BOARD OF APPEALS, CITY & COUNTY OF SAN FRANCISCO

Appeal No. **25-050**

NOTICE OF APPEAL

PRELIMINARY STATEMENT FOR APPEAL NO. 25-050

FIRST FLOOR / FOUNDATION PLAN

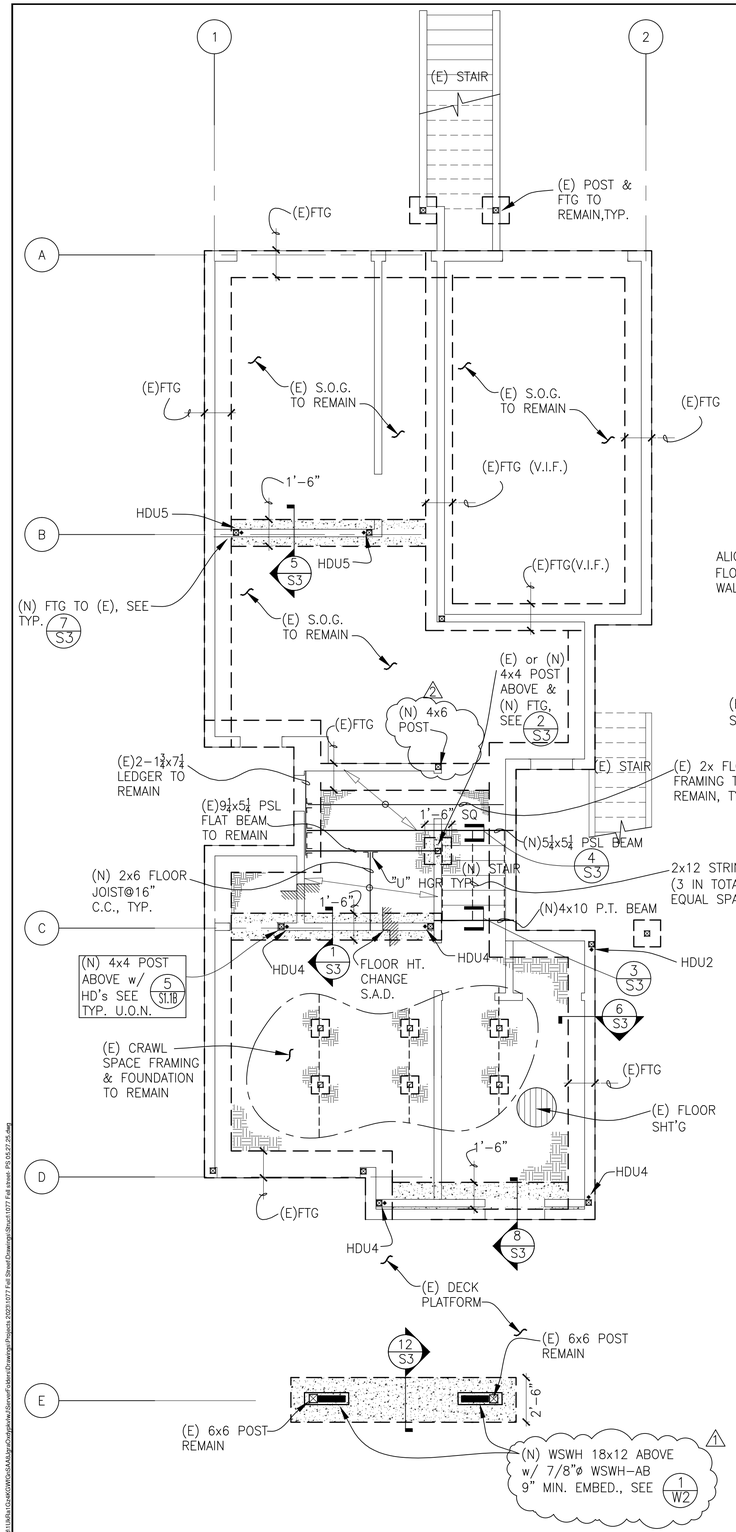
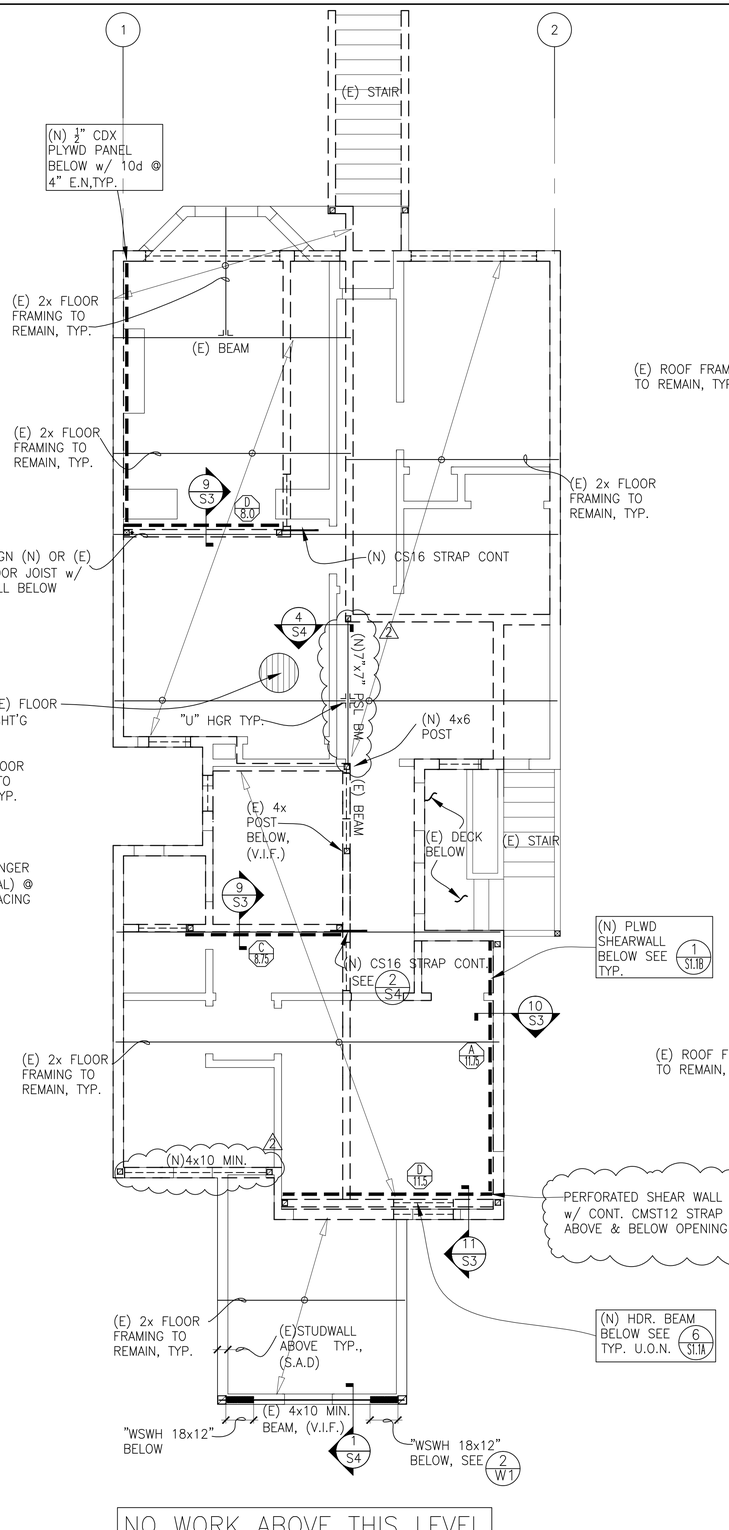
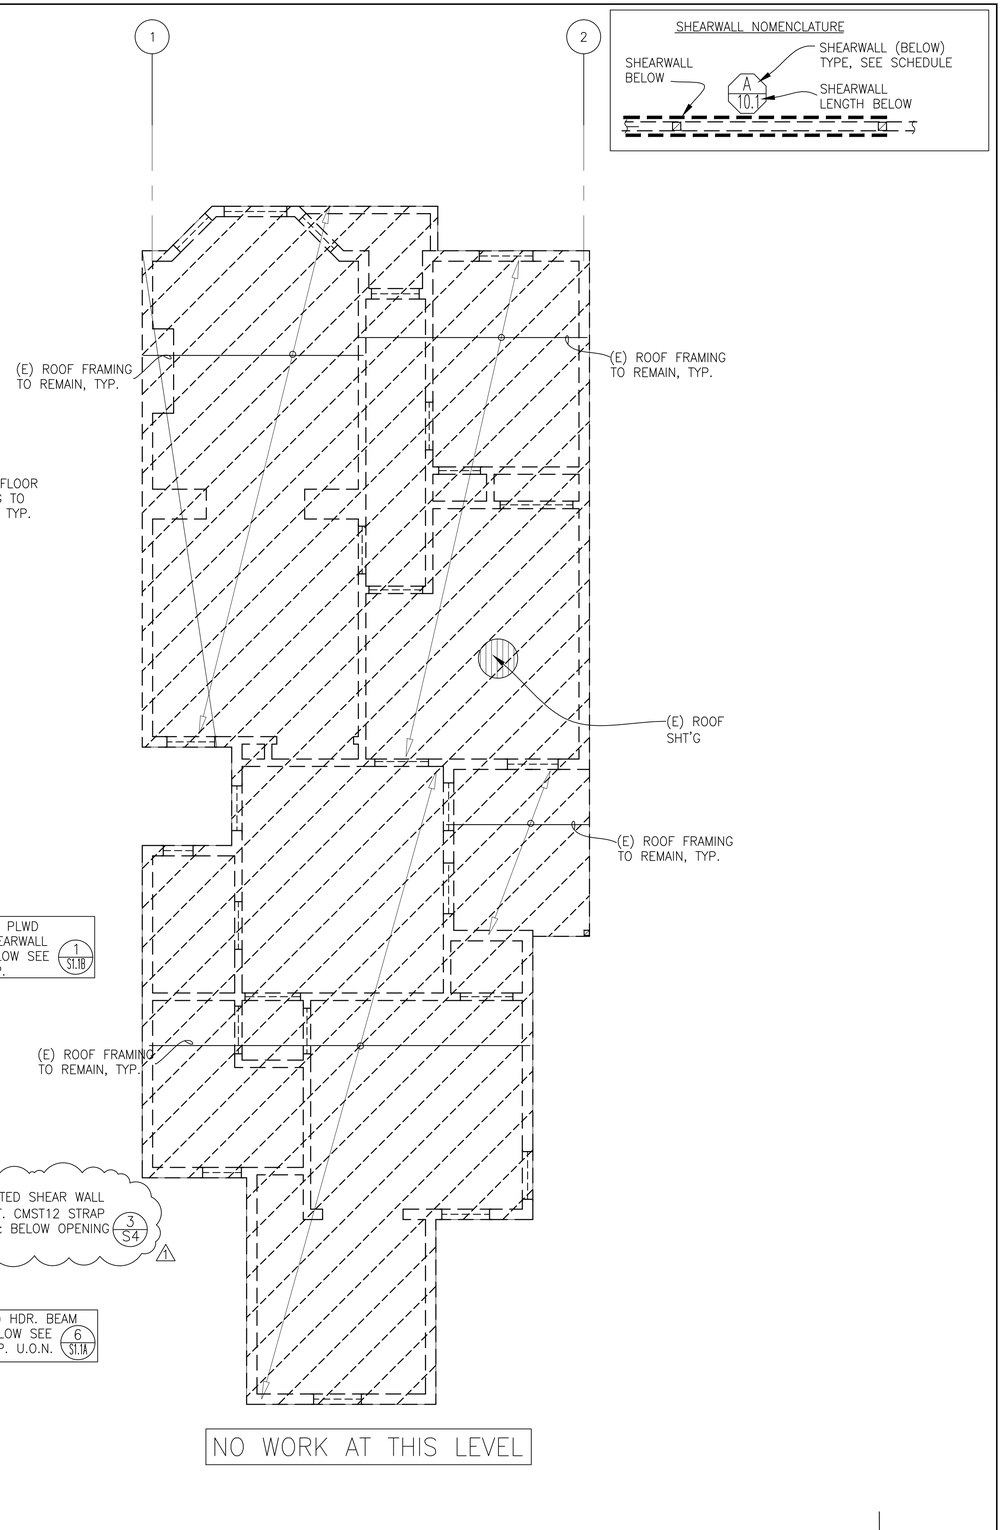
16. Enertia's plans shows shear walls in the N–S (Long) direction also, but do not provide any calculations for these walls (See **Exhibit 6** Sh. S-2 and **Exhibit 5** Calc. Sh. 12 and 13 N-S only). If earthquake and wind forces are calculated, as they are in these permits, the building code (CEBC 503.13, Item 2) requires that the shear walls and related structural elements be designed for these

18. Chiawang Yeh commented that the Enertia 2024 Plan neglected to provide a connection for the cantilevered diaphragm to the main building (See **Exhibit 3** Sh. S2). Drag strut connection and dry rot repair calculations including details are required to be part of the permit set prior to construction. Per CEBC 105.2.1 Emergency repairs: Where equipment replacements and repairs must be performed in an emergency situation, the permit application shall be submitted within the next working business day to the code official. Also CEBC 503.13 requires new or relocated structural elements to be designed as if for a new building per 503.13 item 2.

Line E Foundation check - FTG1

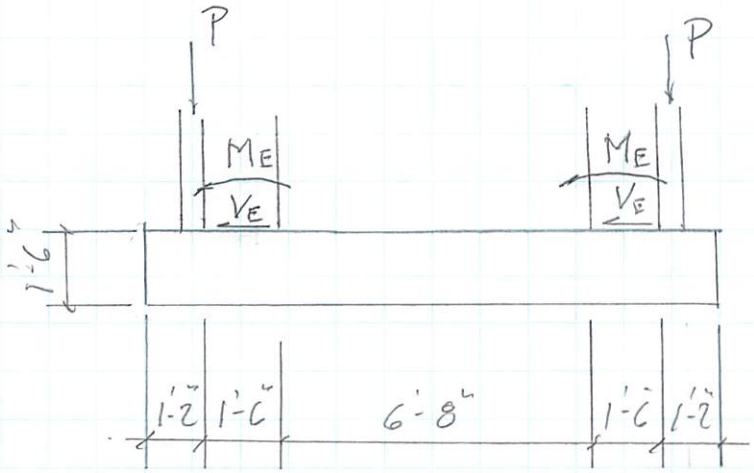
6. Enertia's Plans include a new Simpson Strong Wall at Line E which is supported on a new concrete footing. Code requires that this footing is designed for all code forces including earthquake forces. Enertia's calculations (**Exhibit 2 Calc. Sh. 27**) omitted the earthquake forces from the footing design and no calculations for the two other new shear wall footings were provided. **Exhibit 2** Calc. Sh. 15 show incorrect floor heights of 9 feet when architectural drawings show them at 11 ft. **Exhibit 3** Sh. S2 contains Chiawang Yeh's comment that the architectural elevation does not match the calculation and the strong wall height needs to be verified. **Exhibit 5** Calc. Sh. 10 and Sh. 13 show the 2025 calculations still use incorrect floor heights of 8 feet.

7. My calculations show that with earthquake forces included, the newly constructed footing will fail during a code level earthquake (**See Exhibit 7 Fn 6-15**). To make the new footing comply with code, it would need to be 16 ft long instead of the 12 ft provided. This footing should be modified to satisfy the code requirements.

Wood Shear Wall

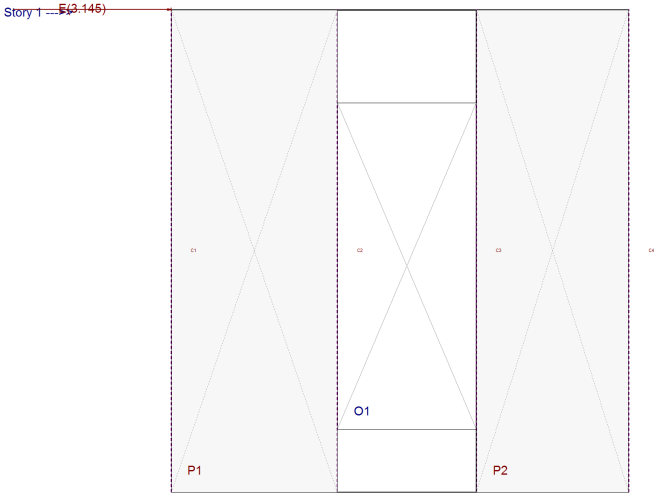
14. Enertia's 2024 Plans showed a window at Line D. (See **Exhibit 3 Sh. S2**) However, the contractors cut an opening for a 3'-6" x 8'-3" door opening in the wall. (See "**Exhibit 12**"). Enertia was required to address this opening size in the 2025 Plans, but Enertia did so incorrectly. The calculations by Enertia used a program called EnerCalc, which I also use. Enertia did not include the horizontal earthquake load in this program. Horizontal earthquake forces tip (overturning) walls over unless they are properly anchored to the floor. I included the earthquake forces in my calculations and found that the solid wall panels on each side of the door jamb require a hold-down (See **Exhibit 7** at P2). Without these hold-down anchors, the perforated shear wall potentially fails and tips over.

1. **42 inch width**

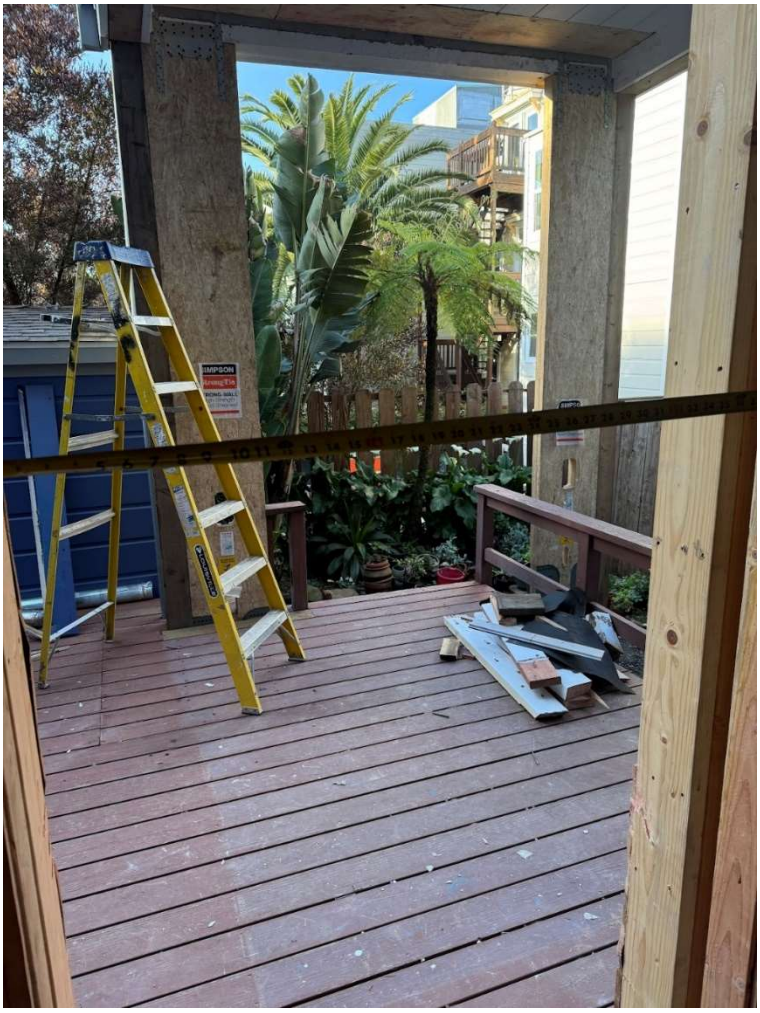
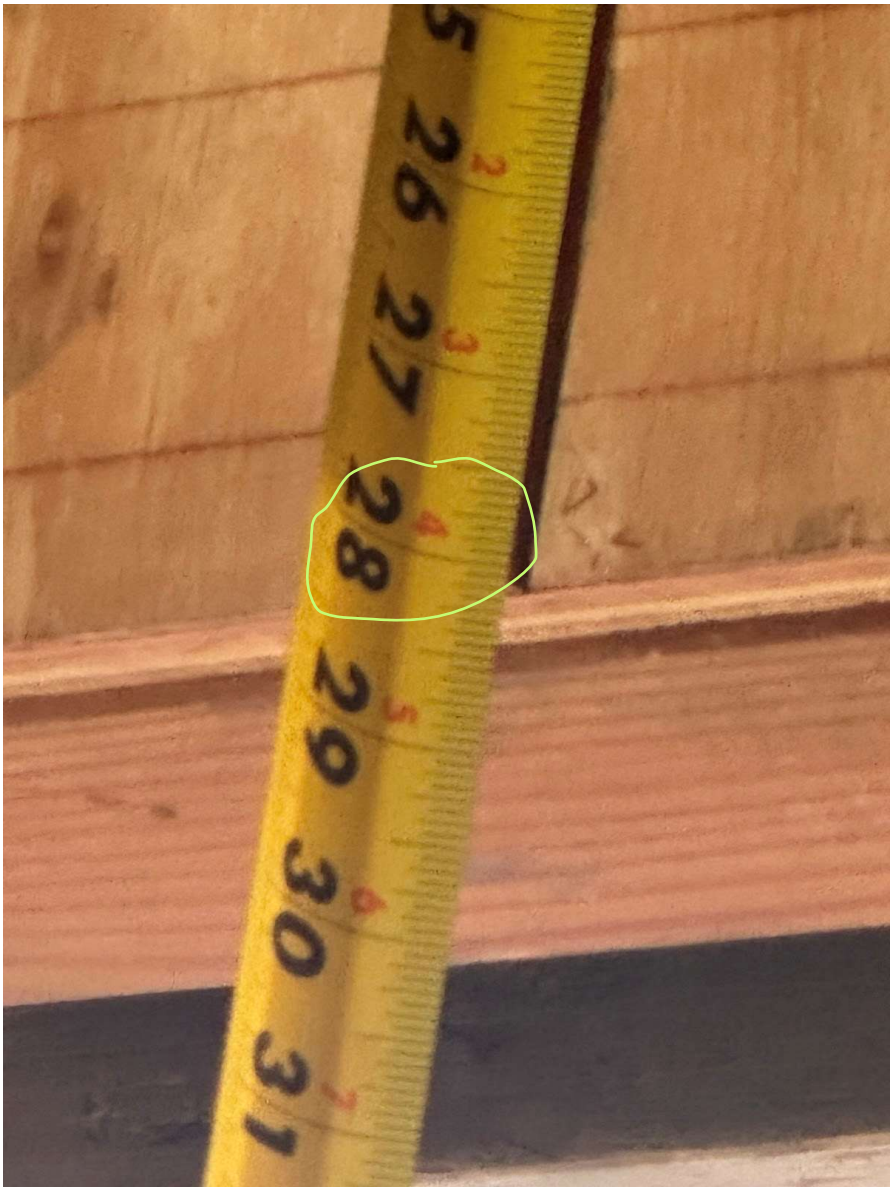
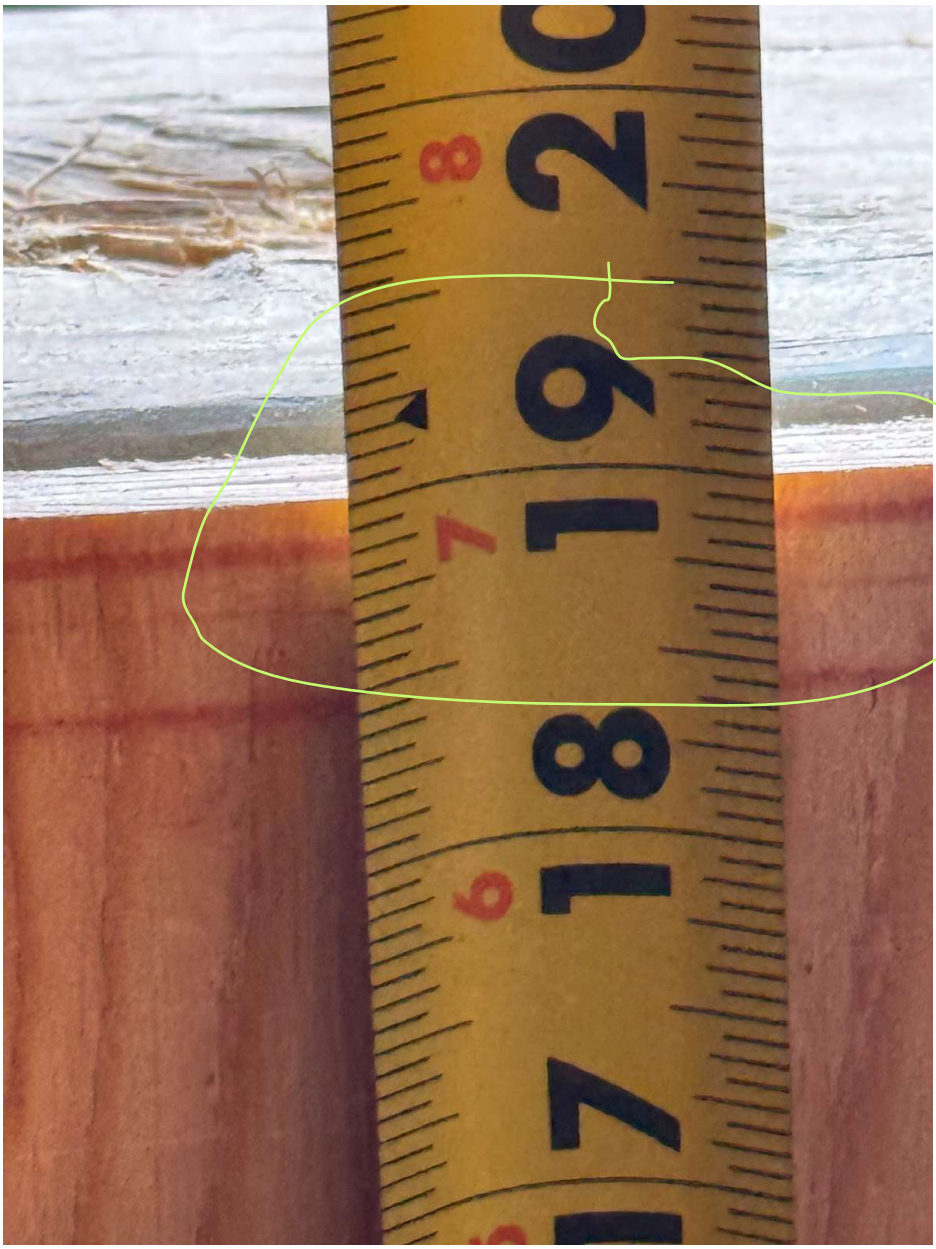
15. The section 8/S3 on Enertia's structural drawings do not show the correct conditions. The shear wall is shown to sit on the floor, but in reality it extends past the floor 15 inches or so and sits directly on the new footing. This makes the shear wall taller and changes the overturning forces. (See **Exhibit 6** Section 8 on S-3)
